LAND USE APPLICATION COMPLETENESS REVIEW

Second Review Comments

Subject Property: 1105 Front Street NE

Reference Nos.: 24-106451-PLN (Class 3 Site Plan Review, Tentative Subdivision Plan, Class 1 & 2 Adjustment, Class 2 Driveway Approach Permit)

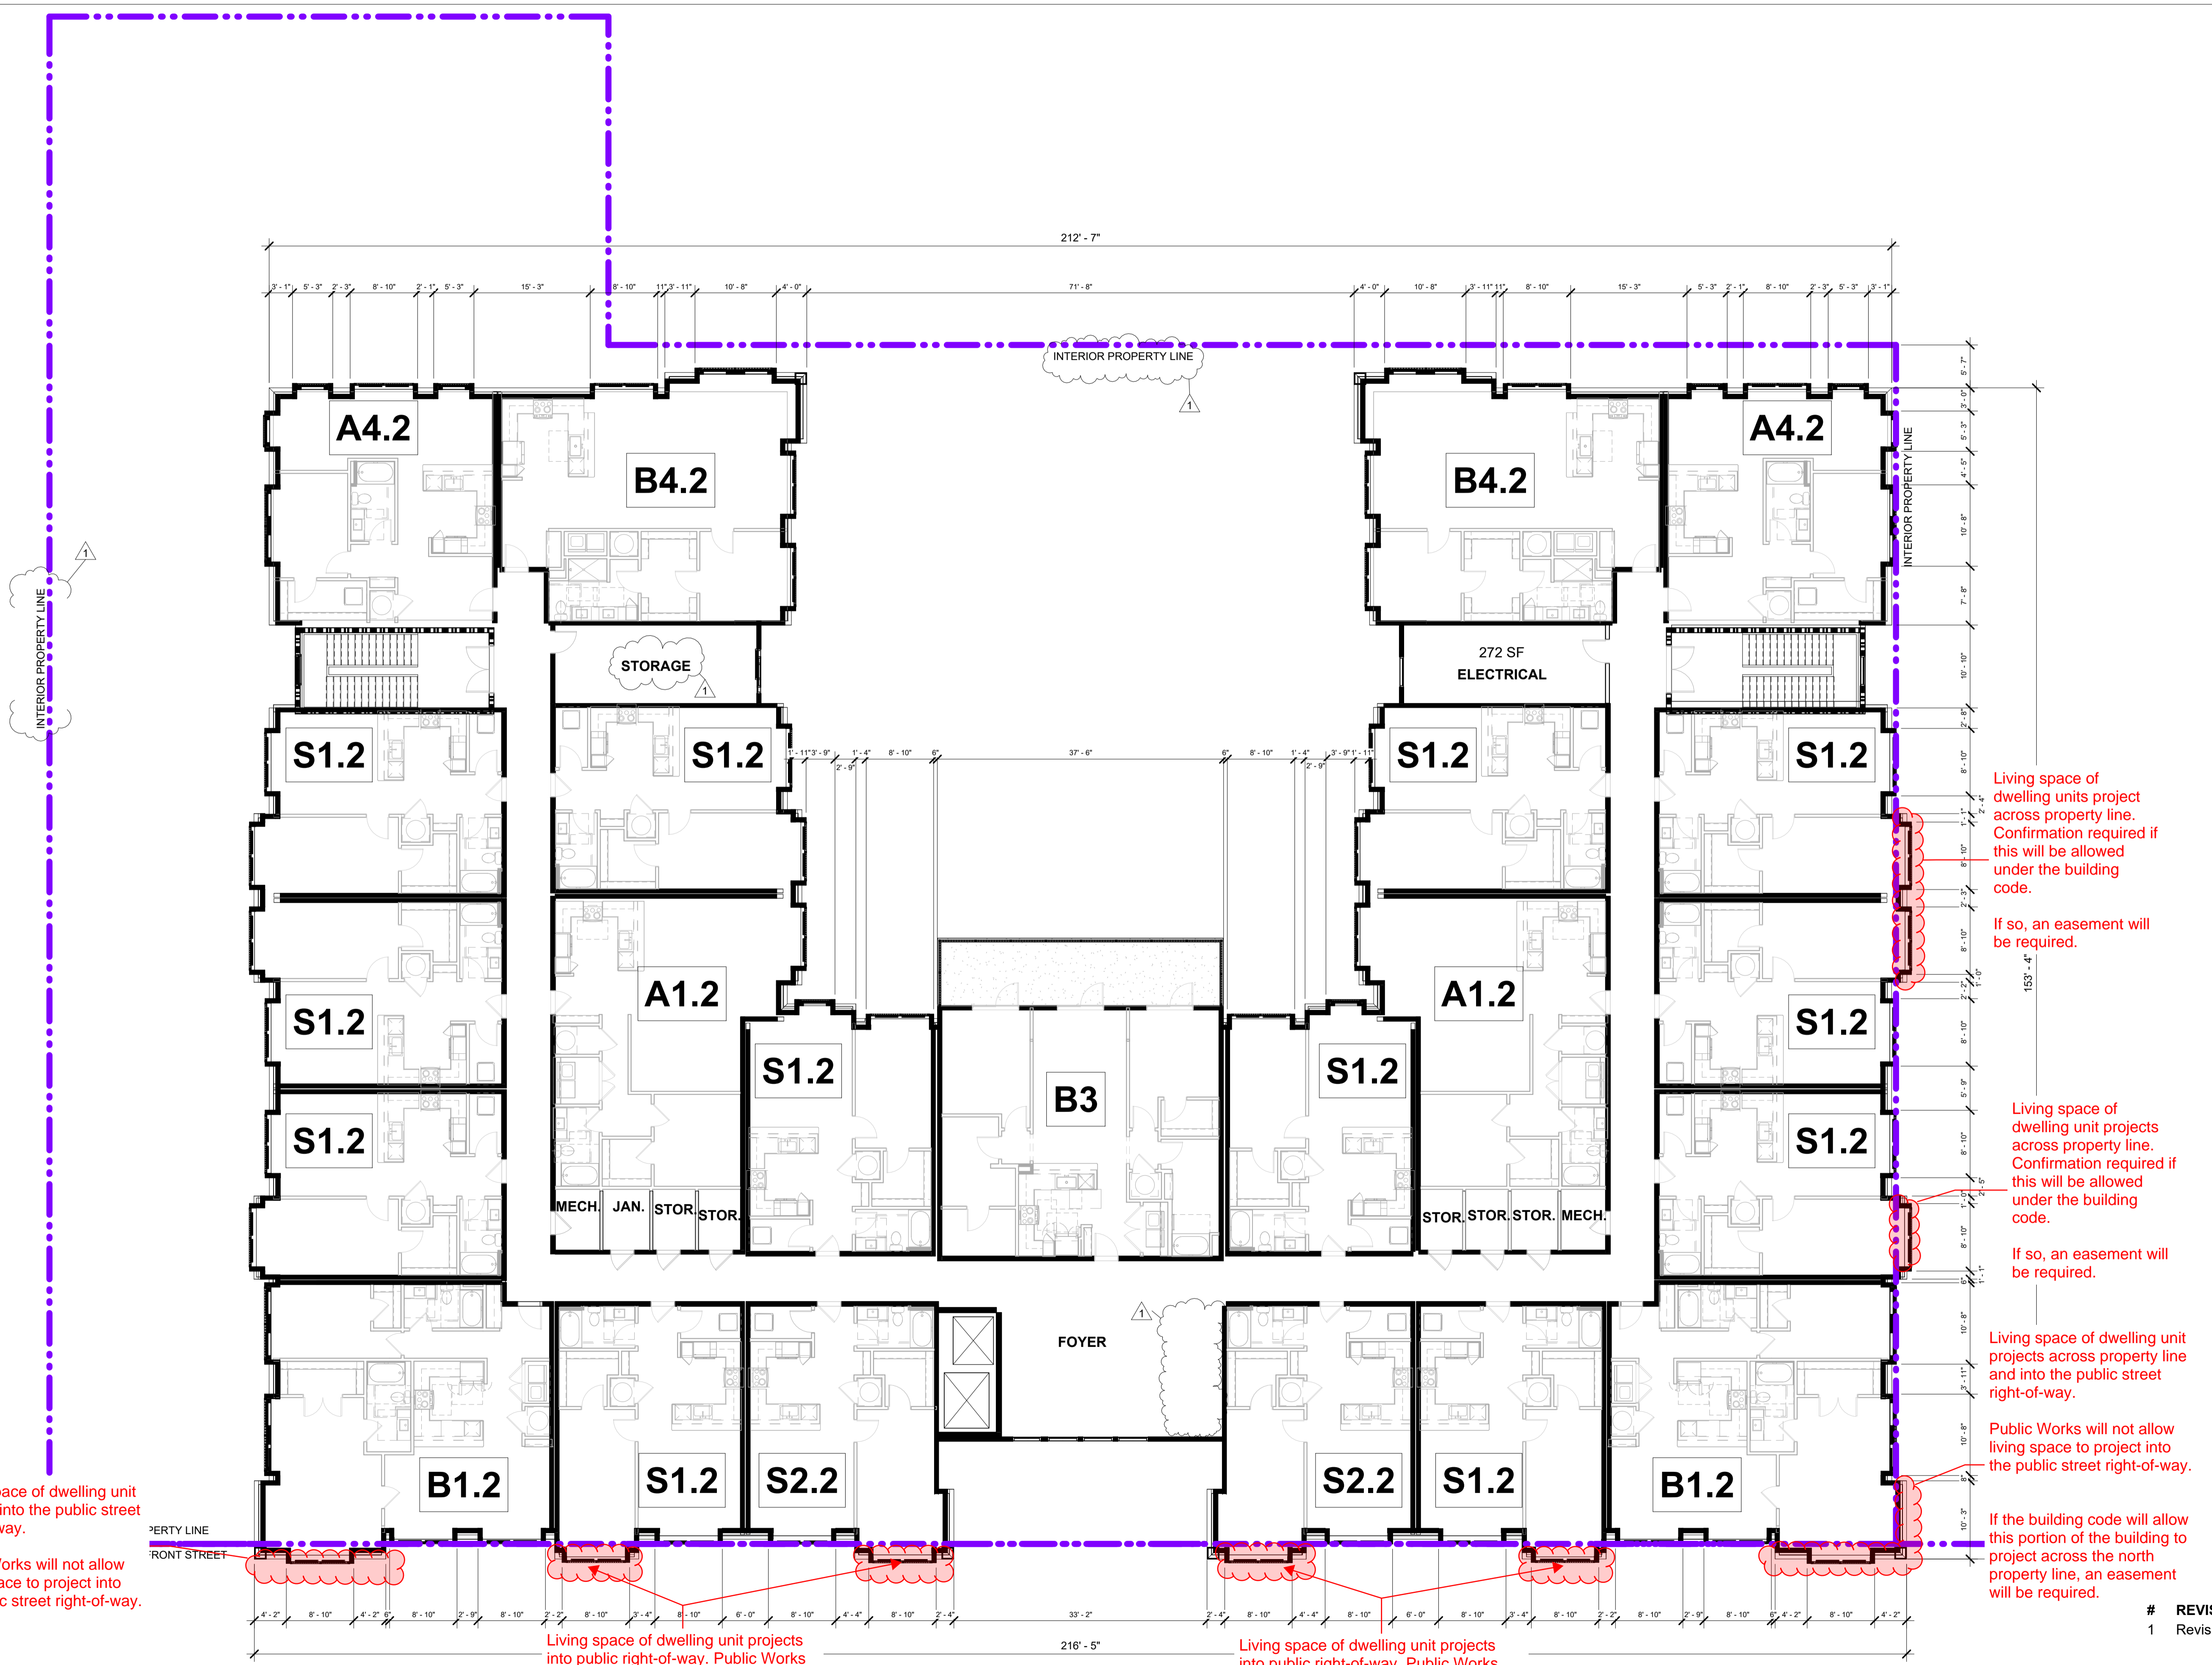
Living space of dwelling unit projects into the public street right-of-way.
Public Works will not allow living space to project into the public street right-of-way.

Living space of dwelling units project across property line. Confirmation required if this will be allowed under the building code.
If so, an easement will be required.

Living space of dwelling unit projects across property line. Confirmation required if this will be allowed under the building code.
If so, an easement will be required.

Living space of dwelling unit projects across property line and into the public street right-of-way.

Public Works will not allow living space to project into the public street right-of-way.

If the building code will allow this portion of the building to project across the north property line, an easement will be required.

Living space of dwelling unit projects into public right-of-way. Public Works will not allow living space to project into the public street right-of-way.

Living space of dwelling unit projects into public right-of-way. Public Works will not allow living space to project into the public street right-of-way.
